## TE Connectivity

Product Change Notification: P-22-023620

Micro K relay components using regrind material.

## Parts with LCP material:

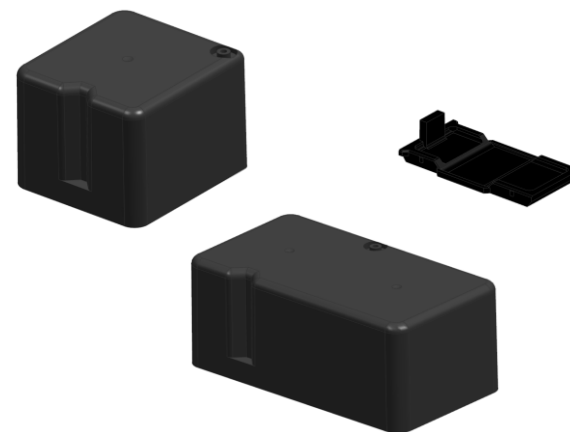
Implementation of the usage of regrind in closed loop for Micro K relay components. This process will help reduce the component environmental footprint.

Material: LCP GF 30%  
Supplier: Celanese  
Supplier grade: Vectra E130i Natur & Black

## Status old:

Up to 25% Regrind

## Status new:

Up to 45% Regrind
